UNITED STATES PATENT AND TRADEMARK OFFICE

APPLICATION NO.	FILING DATE	FIRST NAMED INVENTOR	ATTORNEY DOCKET NO.	CONFIRMATION NO.
10/710,761	08/01/2004	Kun-Chih Wang	NAUP0582USA	4760
27765	7590	10/02/2006	EXAMINER	
NORTH AMERICA INTELLECTUAL PROPERTY CORPORATION P.O. BOX 506 MERRIFIELD, VA 22116			KARIMY, MOHAMMAD TIMOR	
			ART UNIT	PAPER NUMBER
			2815

Office Action Summary	Application No. 10/710,761	Applicant(s) WANG, KUN-CHIH	
	Examiner Mohammad Timor Karimy	Art Unit 2815

DETAILED ACTION

**FIG. 3**

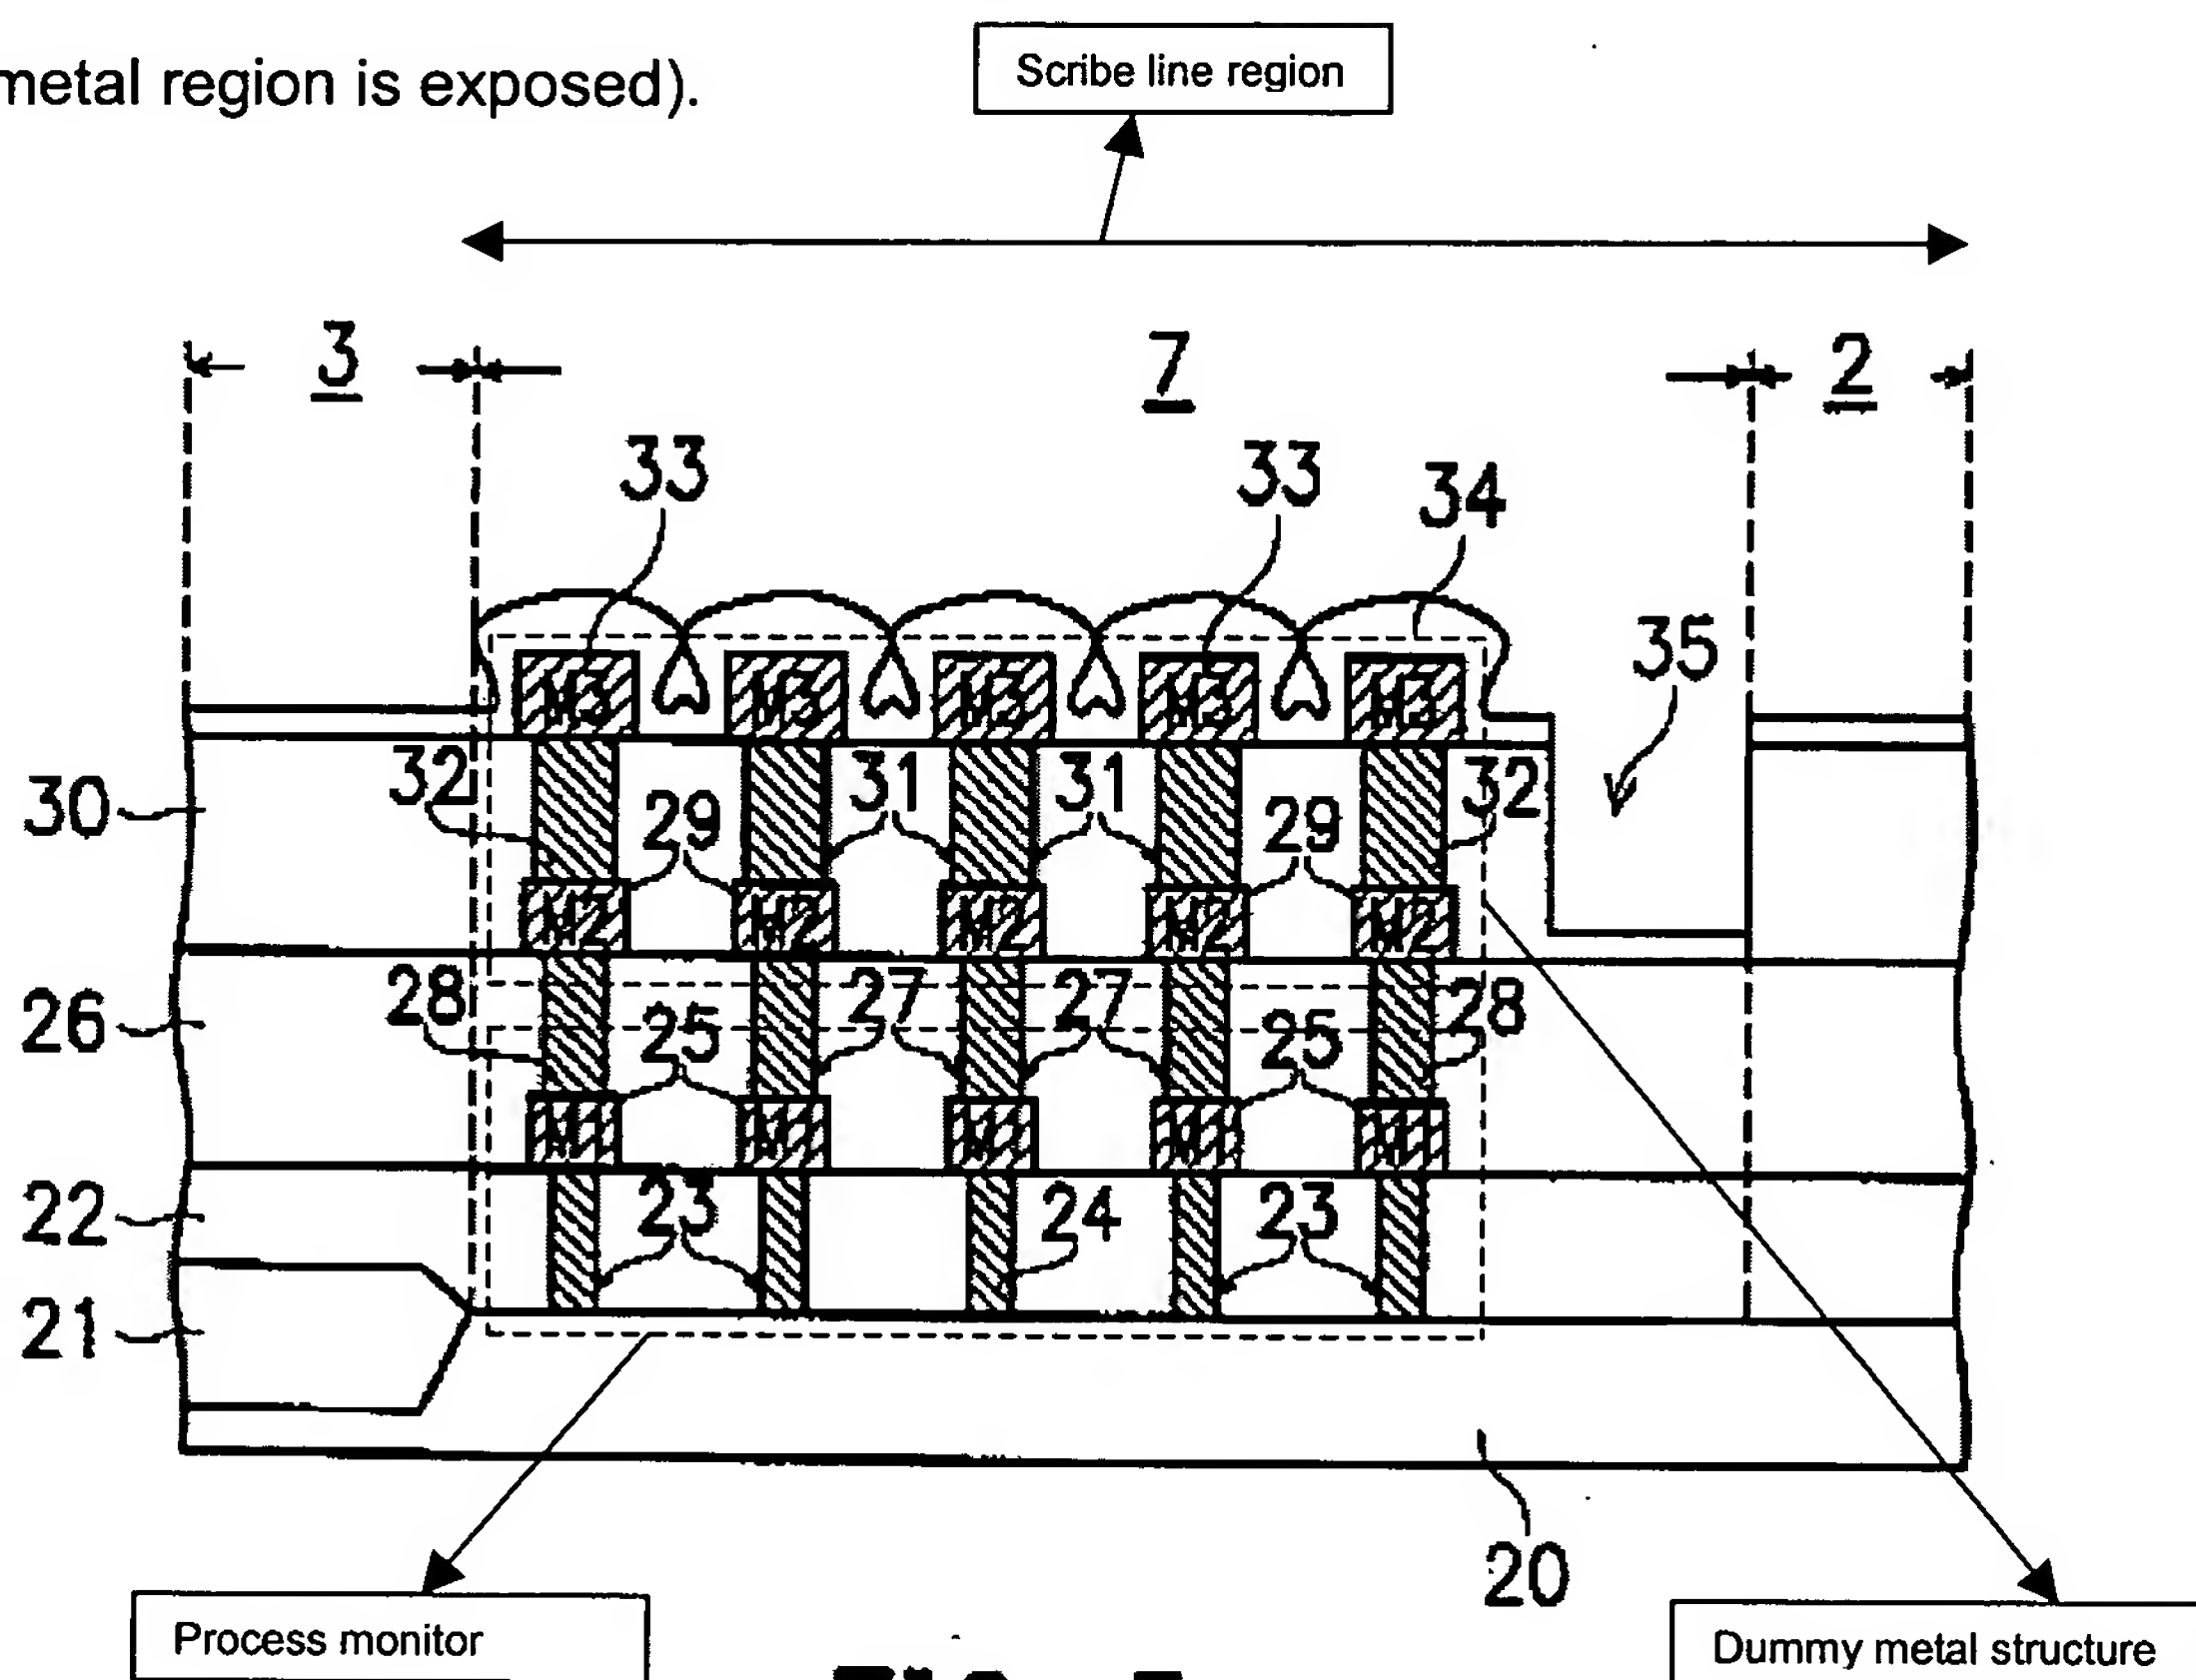
With respect to claim 1, Chang discloses in figures 3-7, a scribe line structure, comprising:

a plurality of dielectric layers (22, 26 and 30) formed on the surface of the substrate 20 comprising a structure which would read on the claimed process monitor pattern since the metallic structure 24 & 23, M1, 25 and 27 could function as a structure to monitor metal deposition process.

Chang further teaches a dummy metal structure (M3, figure 3) formed on the surface of the substrate 20 connecting with the process monitor pattern and exposed in

the scribe line region (note that prior to the deposition of the protection layer 34, the dummy metal region is exposed).

With respect to claim 3, Chang discloses the scribe line structure of claim 1 wherein the dummy metal structure (see fig. 3 above) comprises a plurality of dummy vias (note the vias in the dummy metal region in fig. 3 above).

With respect to claim 4, Chang discloses the scribe line structure of claim 1 wherein the dummy metal structure comprises a plurality of metal layers (see fig. 3 above).

With respect to claim 7, Chang discloses the scribe line structure of claim 1 wherein the surface of the substrate further comprises a protective layer 34 covering two sides of the surface of dielectric within the scribe line region (see figure 3).

With respect to claim 8, Chang discloses a scribe line structure comprising:
a substrate 20, the surface of the substrate comprising at least a scribe line region (see figure 3);

Chang further teaches a heat irradiative structure (dummy metal structure – see fig. 3 above) formed in the plurality of dielectric layers (22, 26 and 30) connecting the plurality of dielectric layers with the surface of the substrate and exposed in the scribe line region (note that prior to the deposition of the protection layer 34, the dummy metal region was exposed).

With respect to claim 13, Chang discloses the scribe line structure of claim 8 wherein the heat irradiative structure (dummy metal region, see figure 3) connects with the process monitor pattern (see figure 3 above).
